Standards Subcommittee

March 13, 2024, Vancouver, BC, Canada.

L.3.1 Standards Working Group on the Continuous Revision of C57.12.00

L.3.4 WG Standards Transformer on Continuous Revision for C57.12.90

Figure 2 —Induced-voltage test for Class II power transformers

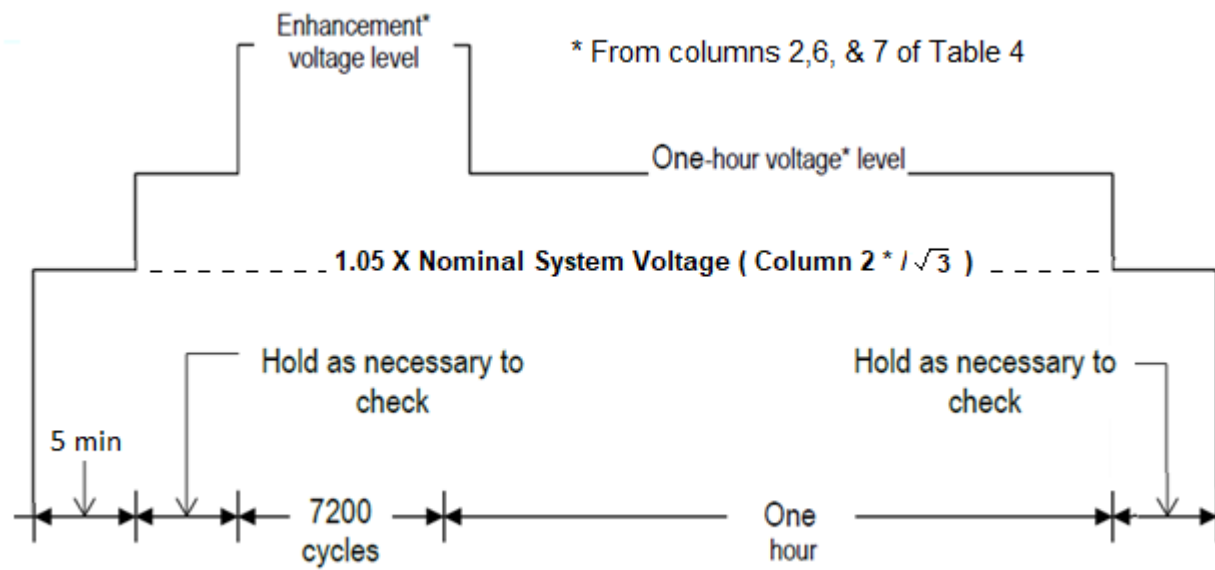
1. Changes to Low Frequency Tests from Ajith Varghese's RLFT TF in the Dielectric Test SC. Final survey approved by TF and SC in the Spring 2023 meeting. Text in black is existing, red is revised, blue is added.

5.10.5.5 Induced-voltage test for Class II power transformers

With the transformer connected and excited as it will be in service, an induced-voltage test shall be performed as indicated in Figure 2, at voltage levels indicated in Columns 6 and 7 and **1.05 times the line to ground voltage per column 2 of Table 4**. Minimum line-to-ground induced test levels for Class II power transformers shall be a multiple of corresponding line-to-ground nominal system voltage as follows: 1.58 times for one-hour tests and 1.8 times for 7200 cycles enhancement level tests.
